**DATE:** March 17, 2023

**TO:** Chairwoman Carlotta Harrell, Henry County Commission  
**ATTN TO:** Yaritza Nieves, Planner III, Henry County  
**FROM:** Mike Alexander, Director, ARC Center for Livable Communities  
**RE:** Development of Regional Impact (DRI) Review

**Name of Proposal:** North Bridges Road Mixed Use DRI 3866

**Description:** A DRI review of a proposal to construct 862 multi-family residential units and 5,000 SF of commercial space on a 54 acre site off of North Bridges Road in Henry County.

GRTA SITE PLAN

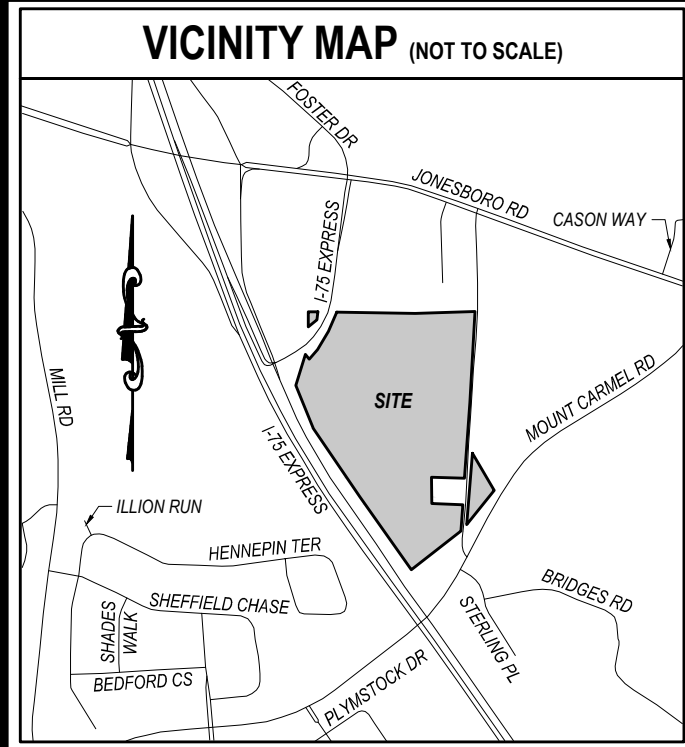
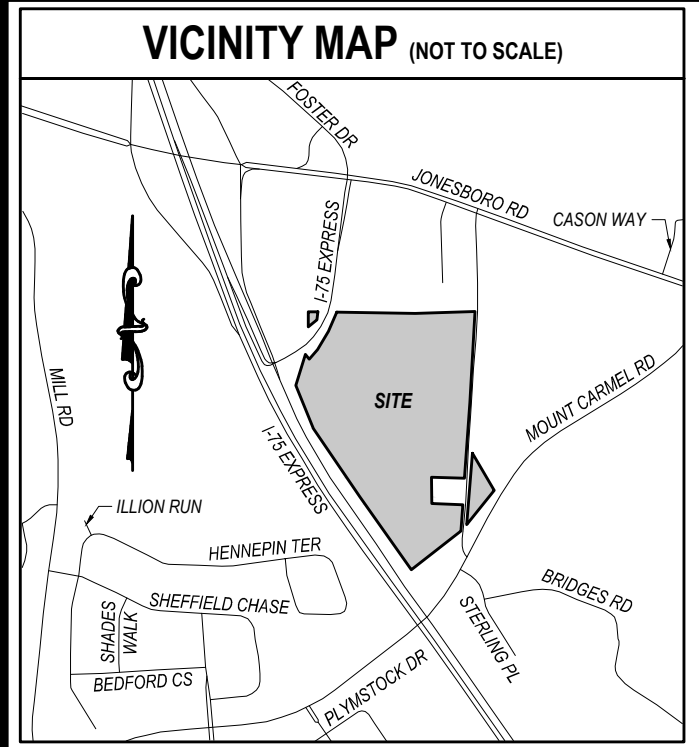
*A total of 1,610 parking spaces are provided which is less than the 1,724 spaces required which will require a variance. Regional multi-modal transportation policies are supportive of reduced parking and a further modest parking reduction may be warranted.*

A total of 1,610 parking spaces are provided which is less than the 1,724 spaces required which will require a variance. Regional multi-modal transportation policies are supportive of reduced parking and a further modest parking reduction may be warranted.

The indicated overall density is 16 du/gross density. Applicant should provide accurate calculations to reflect compliance with Comp Plan as Mixed Use per Henry County FLUM max. net density is 16 du/nua for this property. Net acres is less floodplain, R/W, and detention ULDC Appendix A. Master list of definitions. Gross acres = 54 less +/- 7.5 acs. Floodplain = 46.5 Net Acres; 862 units / 46.5 nua = +/- **18.54 Net Density** (Conservative numbers used for quick calculations).

The density is *more* than allowed. Calculations stated as Net Density, which they are not. Again, the maximum density for Mixed Use is 16 du/nua. As shown, it is not compliant and the applicant should provide correct calculations and if desired, a Comp Plan amendment filed as the density is not consistent with the Comp Plan for this property.
